**Stormwater Management/BMP Facilities  
Record Drawing/Construction Certification  
Review Tracking Form**

County Plan No.: S-50-98  
 Project Name: POWHATAN Woods Phase I  
 Stormwater Management Facility: Large Timber Crib Wall  
 Phase:  I  II  III

## Record Drawing and Construction Certification

RECORD DRAWING  
 TIMBER DAM CONTROL STRUCTURE  
 POWHATAN WOODS  
 JAMES CITY COUNTY  
 VIRGINIA

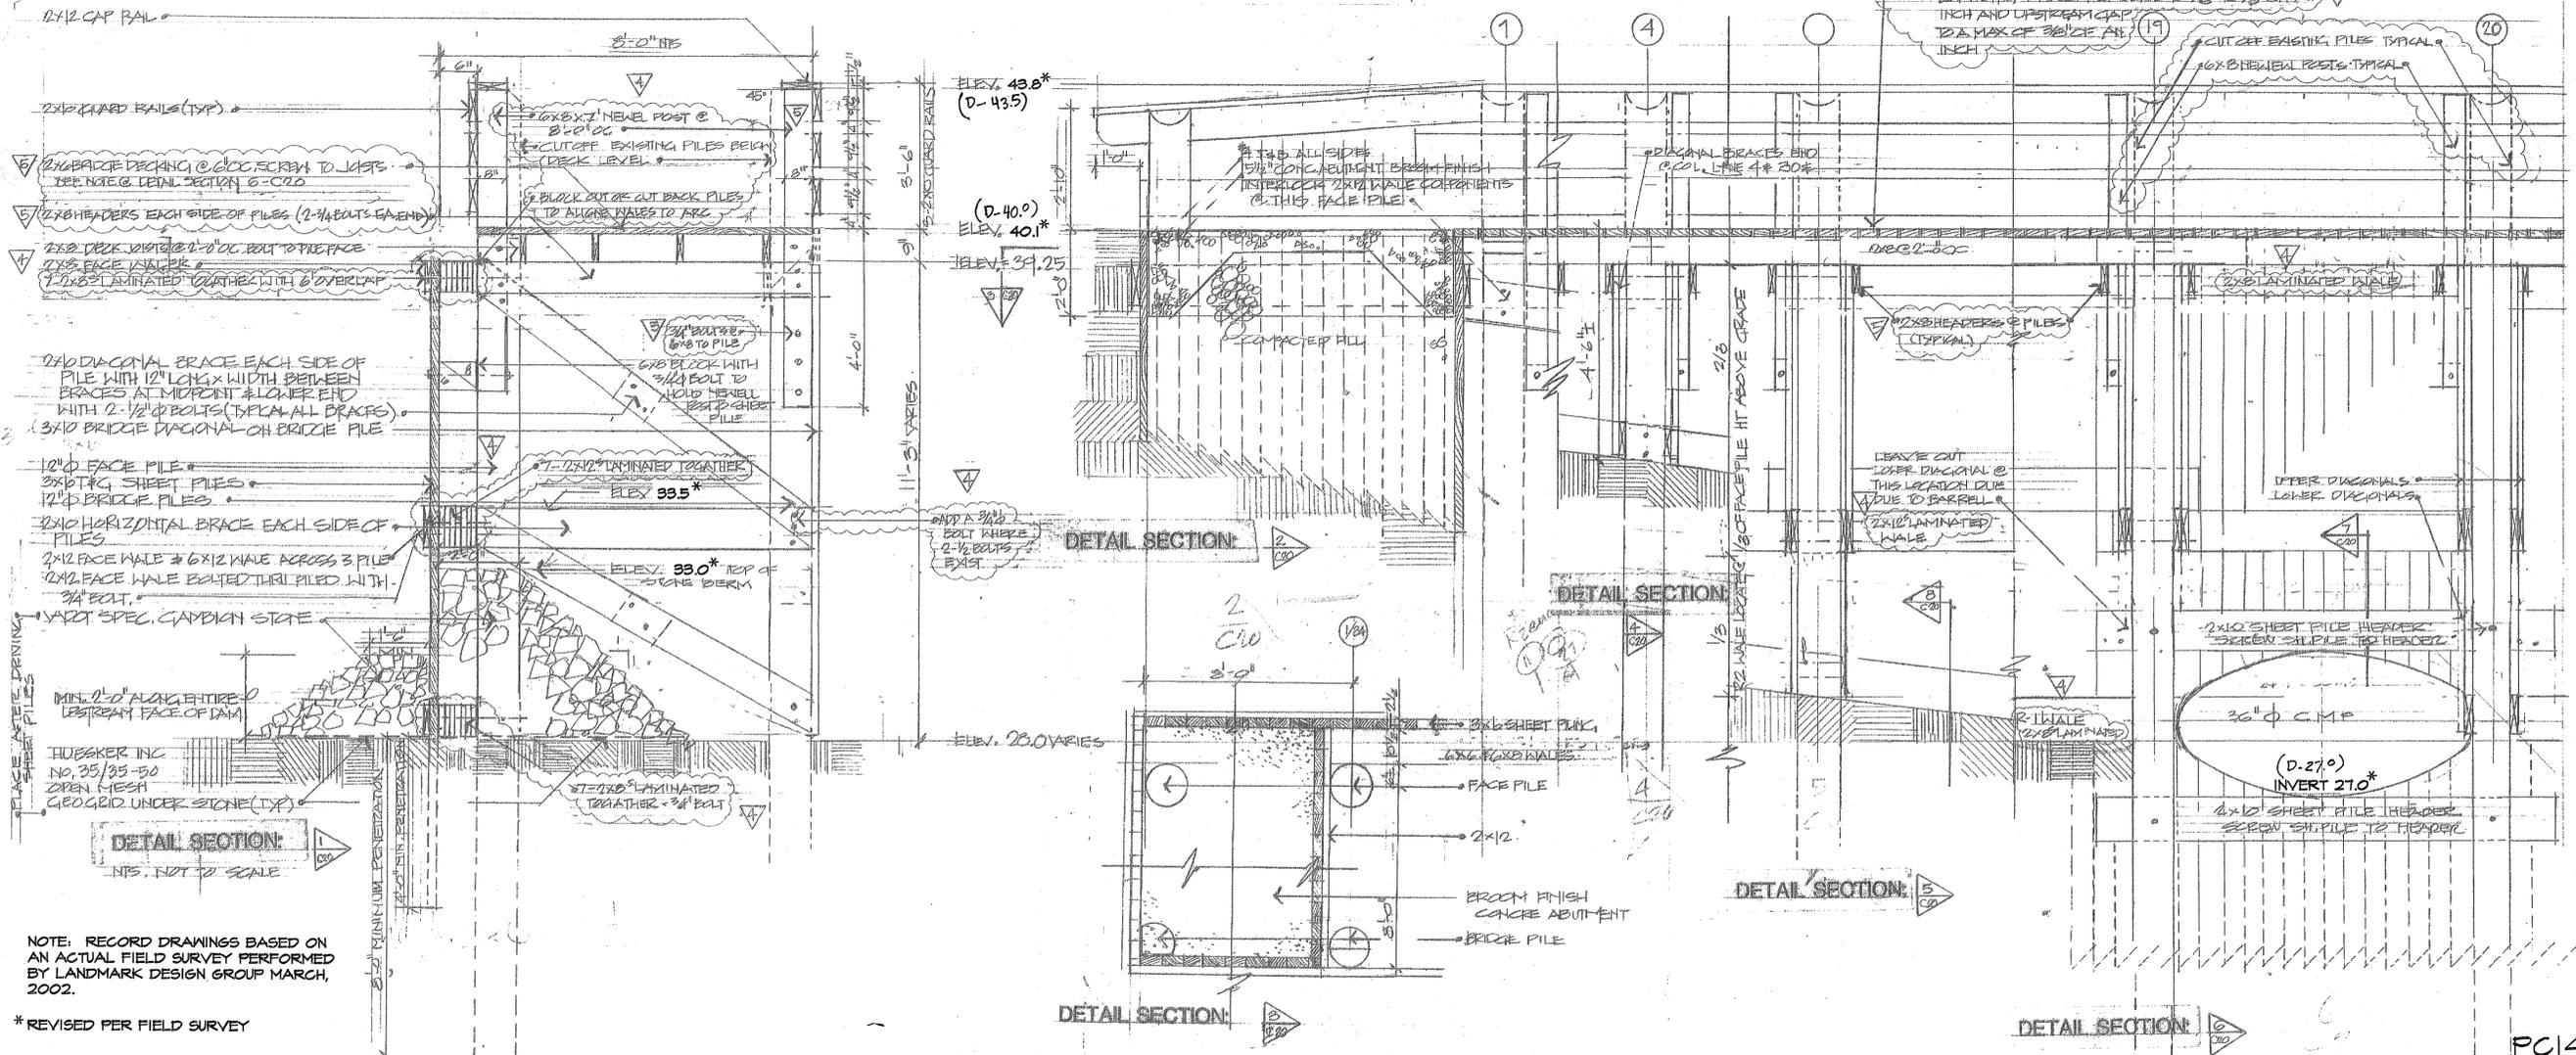
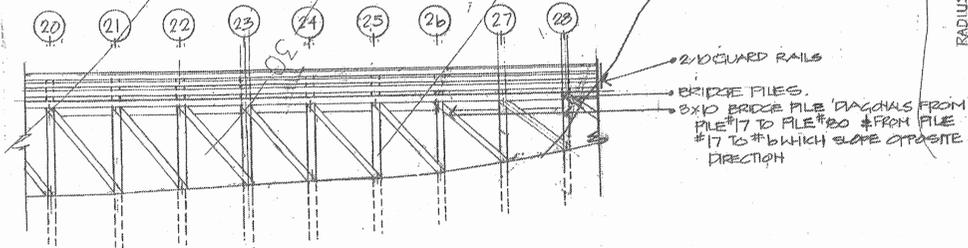
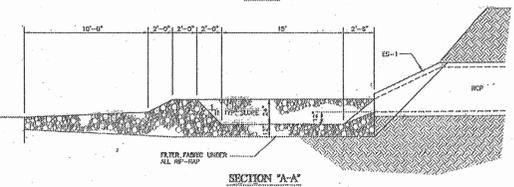
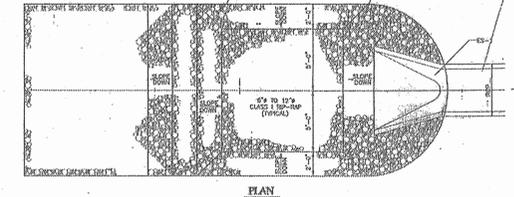
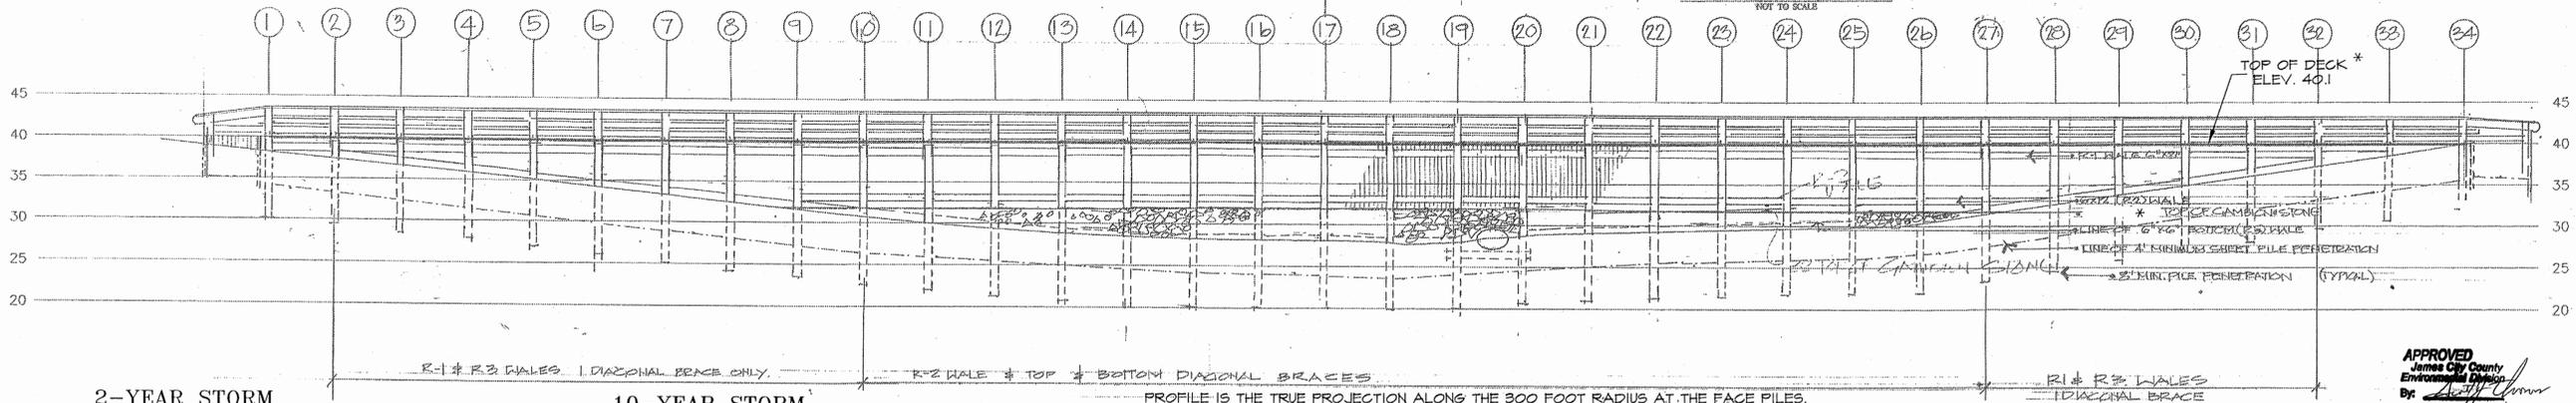
1. The construction certification as offered on Sheet R-1 of the record drawing dated May 22<sup>nd</sup> 2002 is not consistent with the provisions of the approved plan and County BMP certification procedure. Firstly, the professional seal provided with the construction certification is neither signed or dated. Secondly, the certification is not consistent with Note # 18 of the Erosion and Sediment Control Notes on Sheet C-17 of the approved plan set which stated the following:

2. The record drawing set, Sheets R-1, R-2 and R-3 dated May 22<sup>nd</sup> 2002, are **satisfactory**; however, since the construction certification was provided on Sheet R-1 of the record drawing set, the above related comment will need to be resolved before we can accept the record drawings as final. Once resolved, please forward one reproducible and one blue/black line set of the record drawings to our office.

1. The Construction Certification on sheet R-1 has been signed and dated. With regard to your assertion that this certification is not consistent with note #18 of the Erosion and Sediment Control notes on sheet C-17 of the approved plans:

D) This BMP is more of an architectural undertaking than an engineering undertaking. Therefore, we deem that the Construction Certification provided on sheet R-1 and the

application of all professional seals on sheets R-1 through R-3 is in compliance with the pertinent State and Local Regulations. We are perplexed as to why you question the logic of having the Designer inspect the construction of these facilities and certify its' completeness and compliance with the design wherein you issued a building permit based upon the Designer's stamped drawings. Furthermore, this project was approved and construction had commenced prior to the February 1, 2002 issuance date of the County's Storm Water Management/BMP Facilities, Record Drawings and Construction Certification, Standard Forms and Instructions. We have previously objected to and continue to object to your attempts to impose this document on projects whose approvals and construction predated the date of issue of the document.
